TOURING COIL SUSPENSION SHOCK BOLT REPLACEMENT

Recall Number	26E-032		
Product:	Curt Touring Coil Suspension		
Date:	05/27/2026	Labor Rate:	Tandem Axle - 0.8 hrs Triple Axle - 0.9 hrs

Lippert has identified instances where CURT® Touring Coil Suspension (TCS) shock bolts may have been improperly torqued during installation. Although we are confident it is a small quantity, out of an abundance of caution, Lippert is issuing this Safety Recall to replace all shock bolts on units equipped with factory-installed TCS on Lippert chassis manufactured prior to April 23, 2026.

Fig. 1

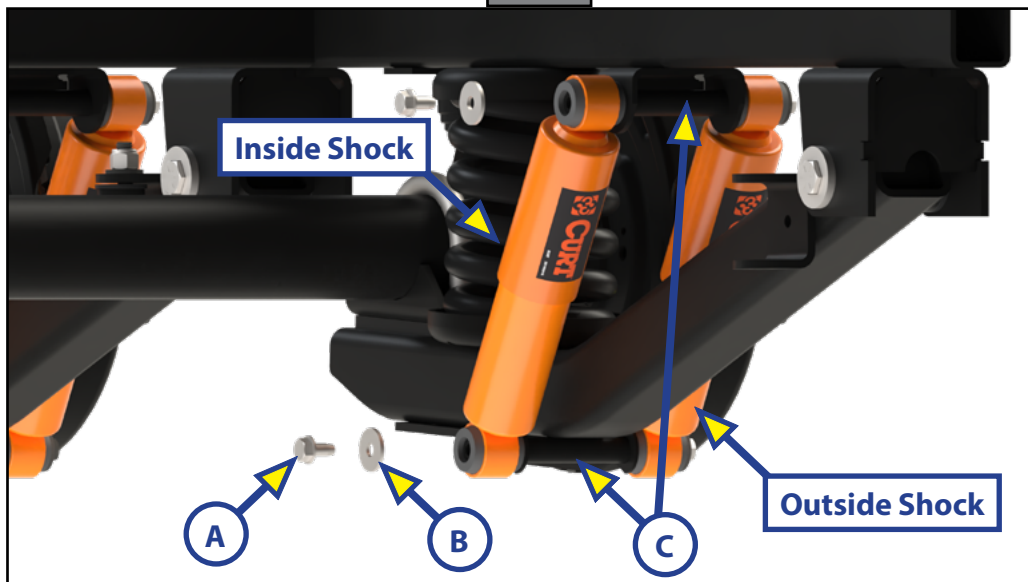
This document outlines the procedure for replacing existing $\frac{3}{8}$ "-16 x $\frac{3}{4}$ " thread forming screw with $\frac{3}{8}$ "-16 x $\frac{3}{4}$ " Grade 8 hex head screws at all Touring Coil Suspension shock absorber locations on a unit. This procedure uses Bolt Replacement Kit PN 2026070484.

1. Starting with the inside shocks, loosen and remove the two existing $\frac{3}{8}$ "-16 x $\frac{3}{4}$ " thread forming screws (Fig. 1A) and washers (Fig. 1B) securing each shock absorber onto its posts (Fig. 1C). Retain washers (PN 249853) for reinstallation in Step 2.

2. Reinstall previously-removed washers onto two new $\frac{3}{8}$ " - 16 x $\frac{3}{4}$ " Grade 8 hex head bolts.
